I-285@ CR 4519/Atlanta Road

GDOT Project Number: STP00-0222-01(001), P.I. No. 752300

Value Engineering Study Report

June 2009

ALTERNATIVE NO.: **B2-8**

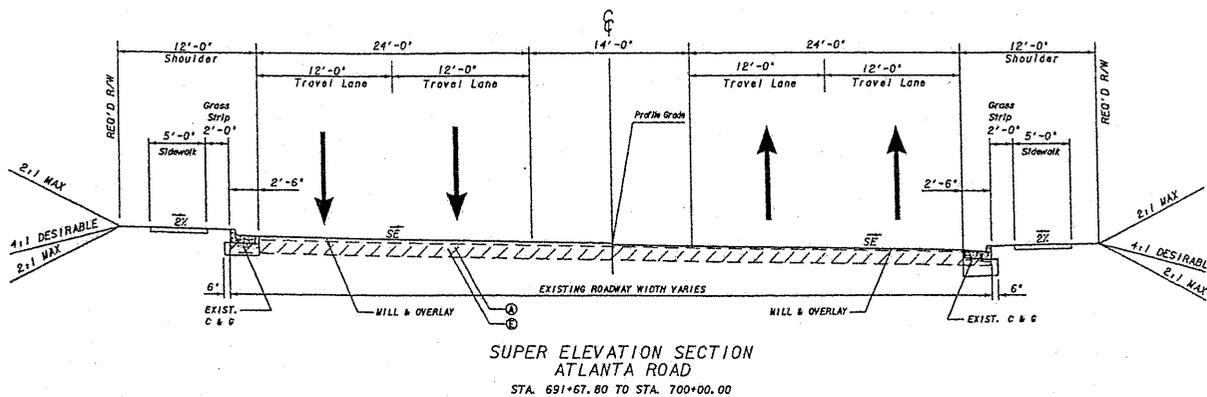
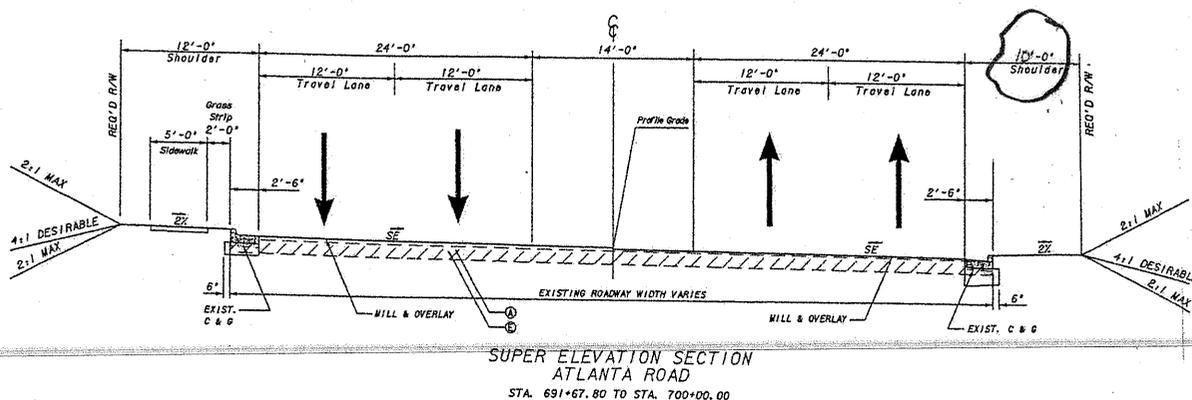
-illustrates hybrid shoulders
Westbound travel maintains urban shoulder,
while eastbound travel changes to a rural shoulder.

Sketch
 Alt. 2-4.1
 Sht. 2 of 4

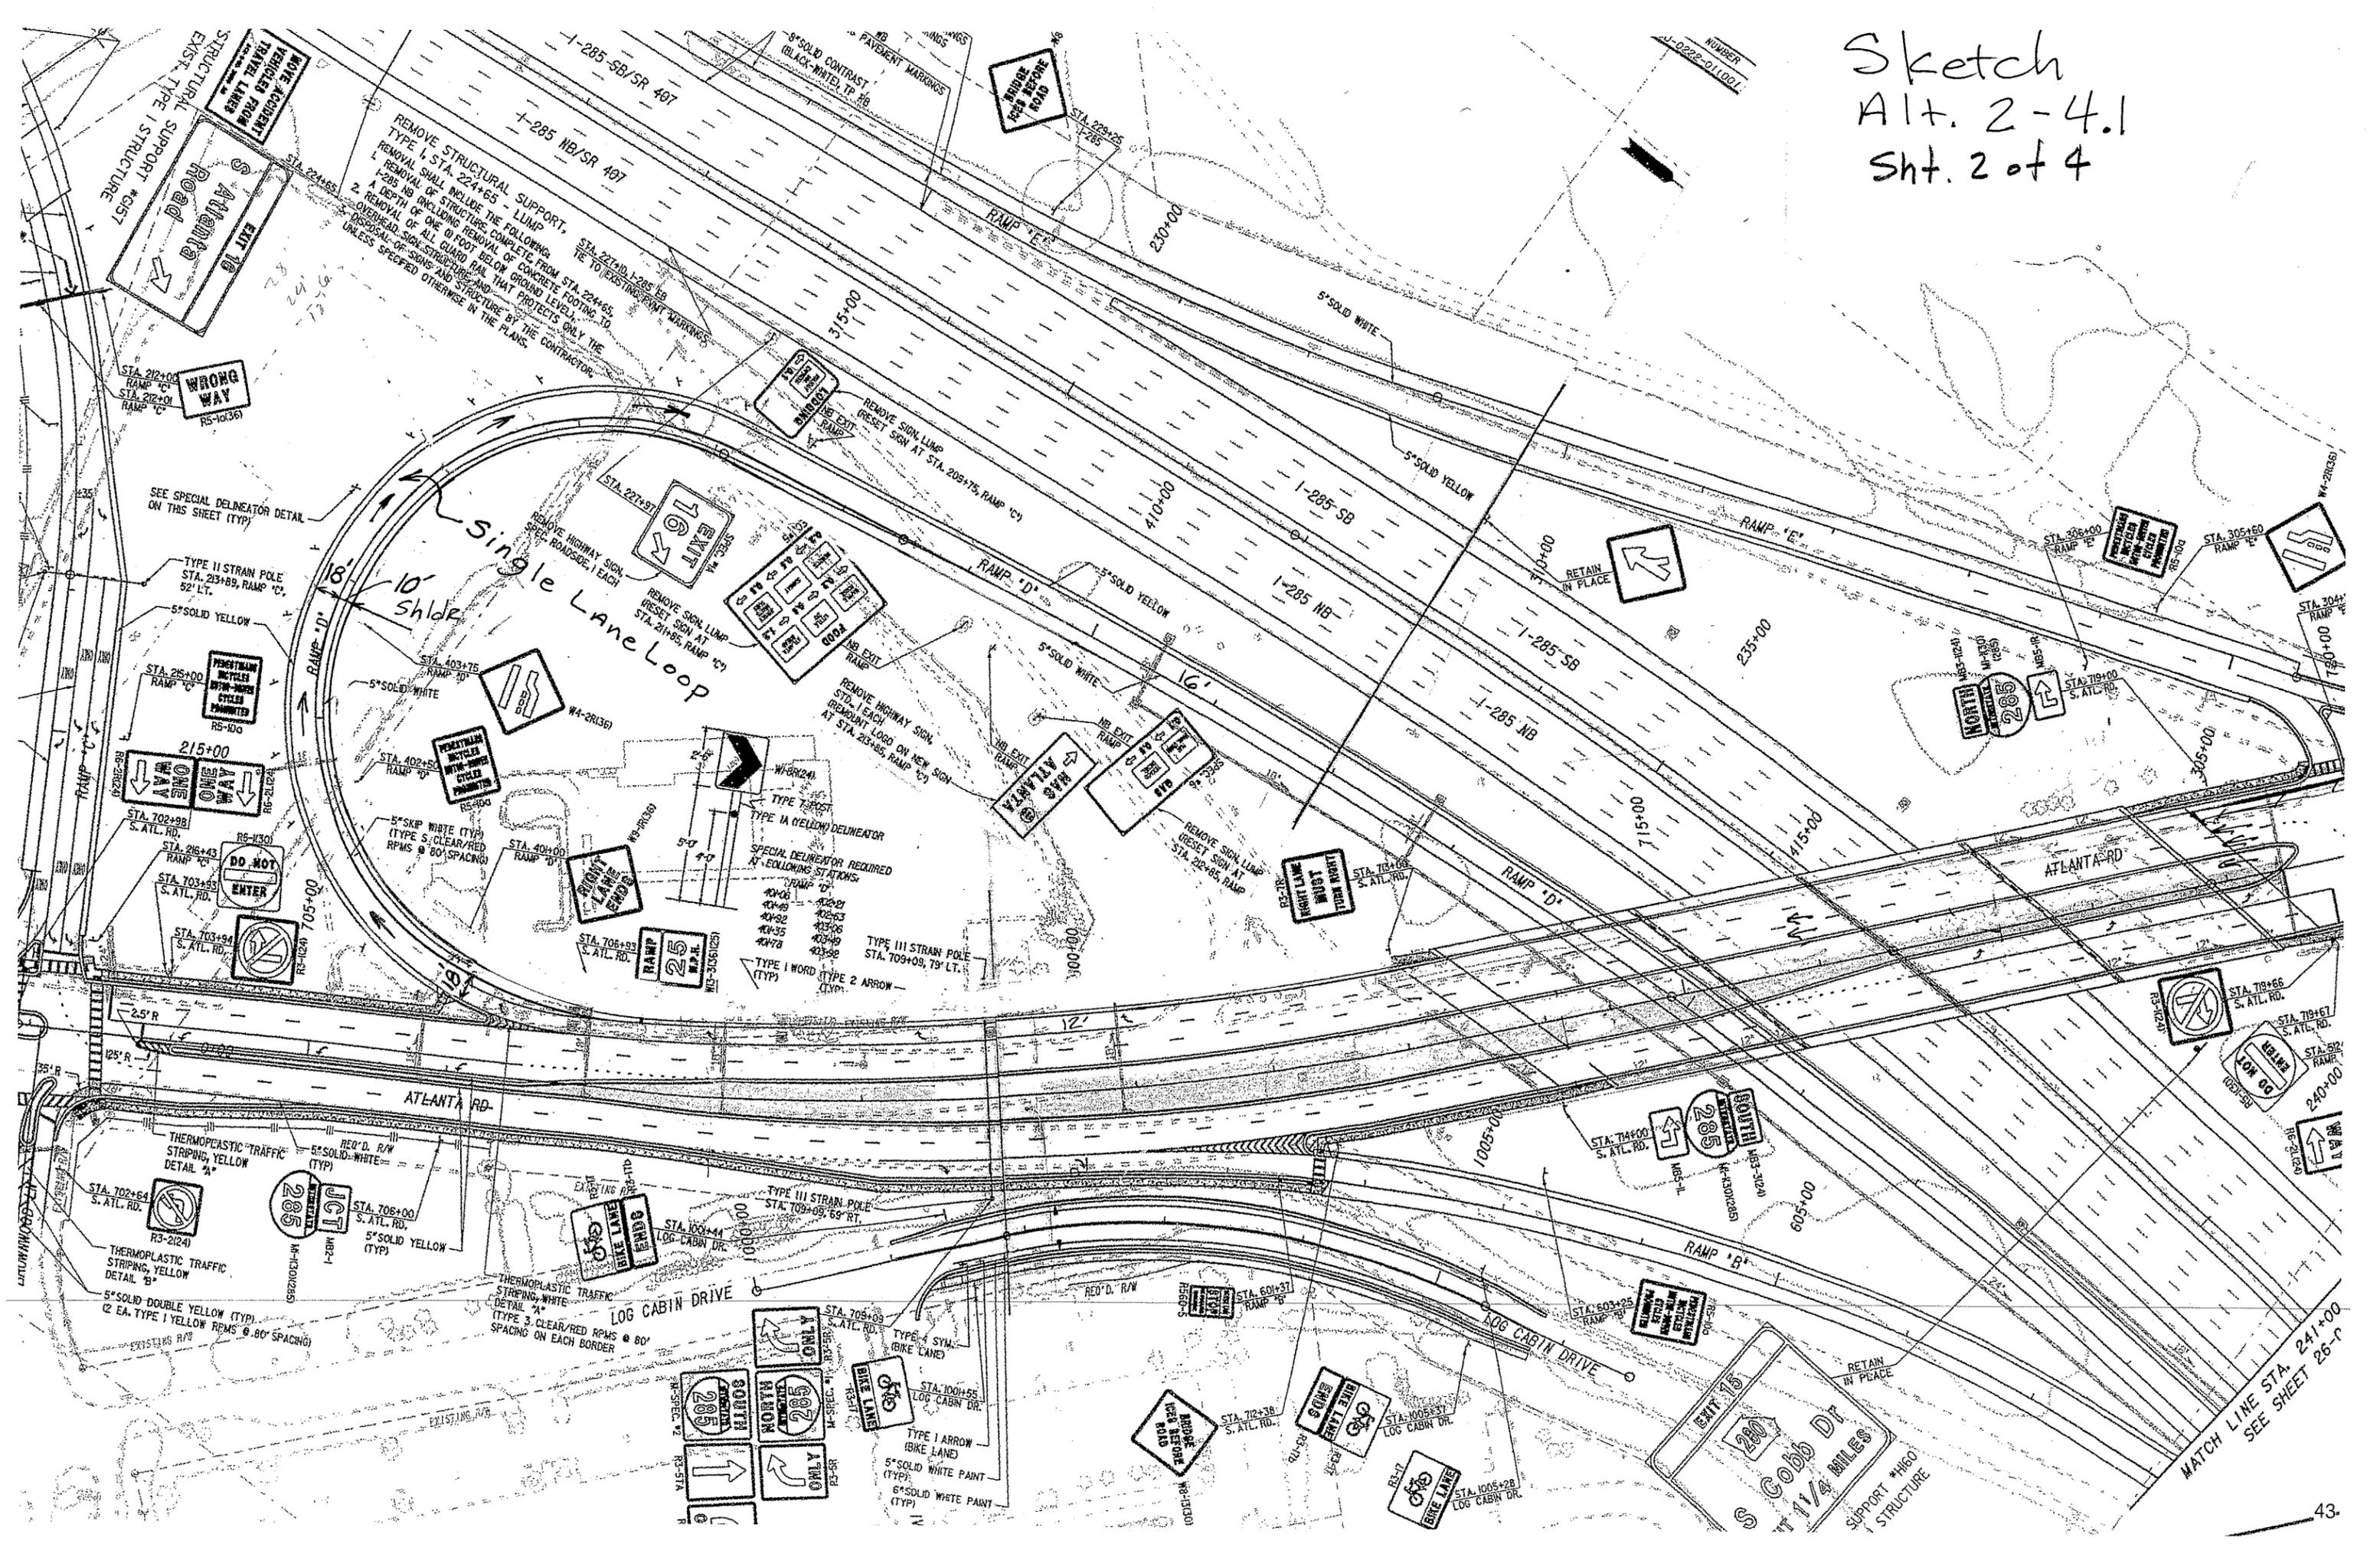
The single-lane loop ramp would be 18 ft wide because of the 202-ft radius. A two-lane loop ramp with a short radius of 202 ft will not operate very efficiently. Two-lane loop ramps should have good geometrics to operate effectively. The current design has the Ramp D exit going from a single lane to two lanes merging back to a single lane in 800 ft. Vehicles speeding up in a two-lane section and then being required to remerge into one lane on a tight curve does not present a safe situation.

ALTERNATIVE NO.: *H2-5*

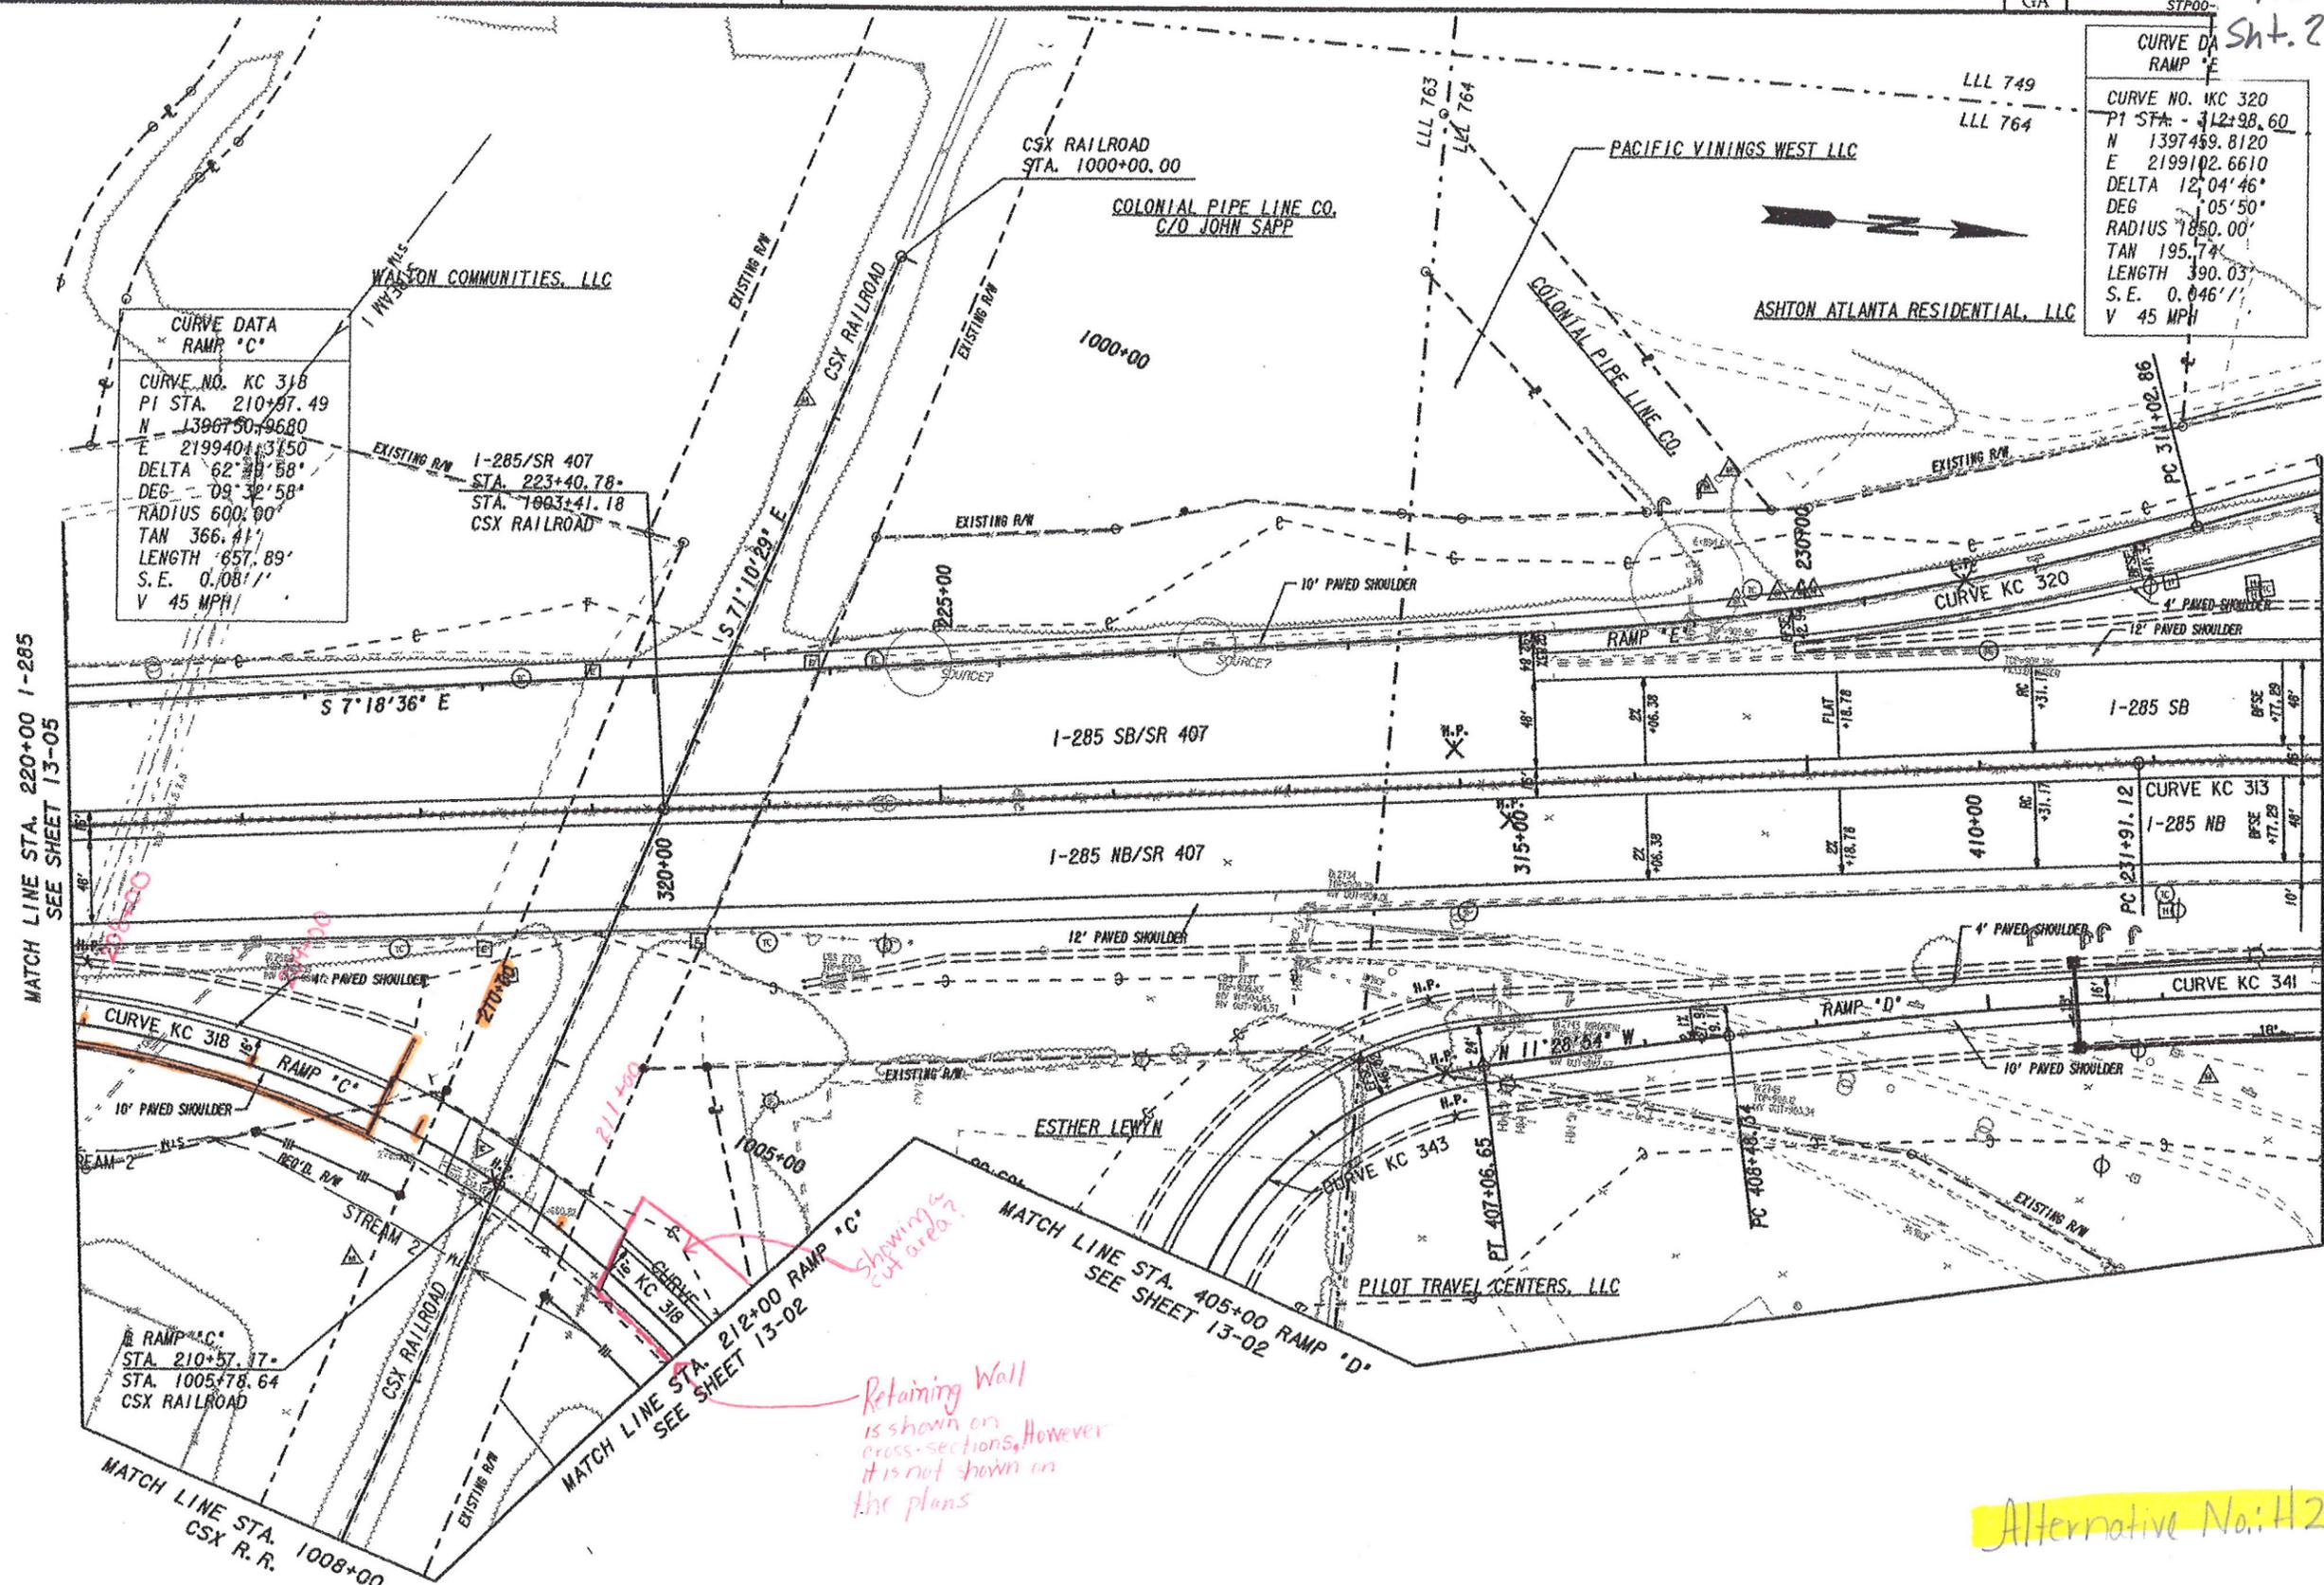
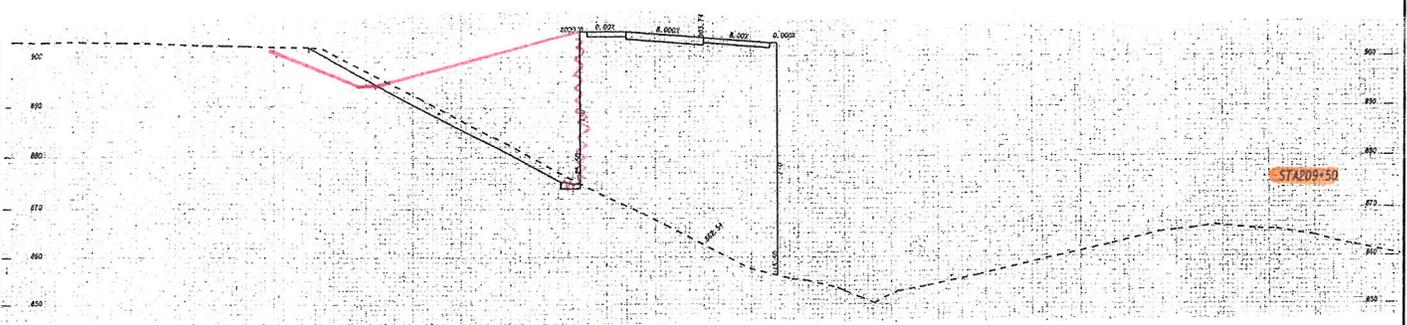
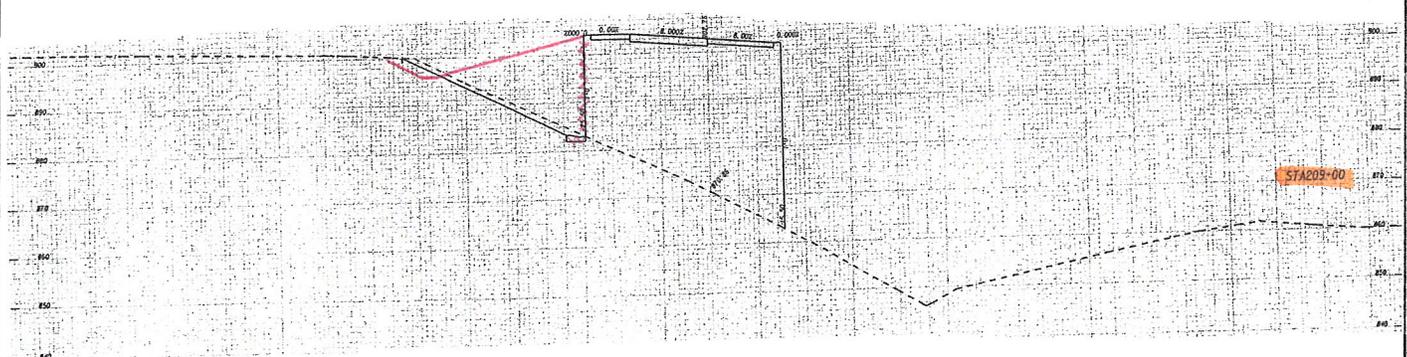
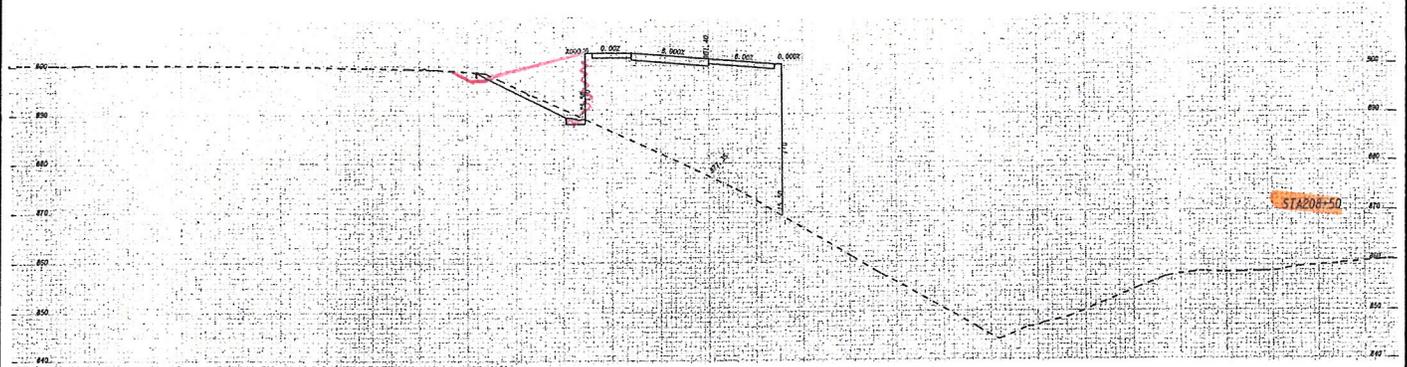
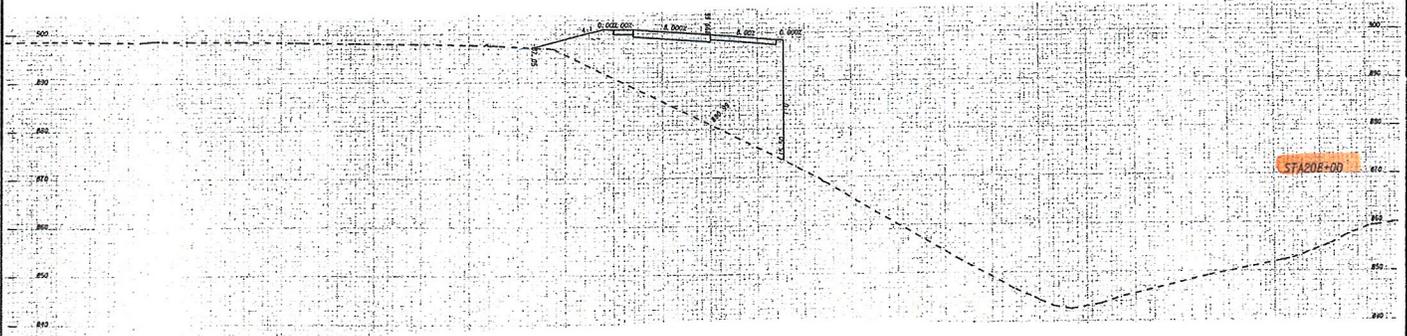
The Ramp C cross-sections show the mechanically stabilized earth (MSE) retaining walls between Sta. 208+00 and Sta. 209+50 on both sides of the bridge.

In the cross-section at Sta 208+00, the retaining wall shown is reflective of plan sheet 13-06. However, beyond 208+00, the cross-sections depict the retaining wall on both sides. This cannot be the case because of the ditch shown on the west side of the ramp.
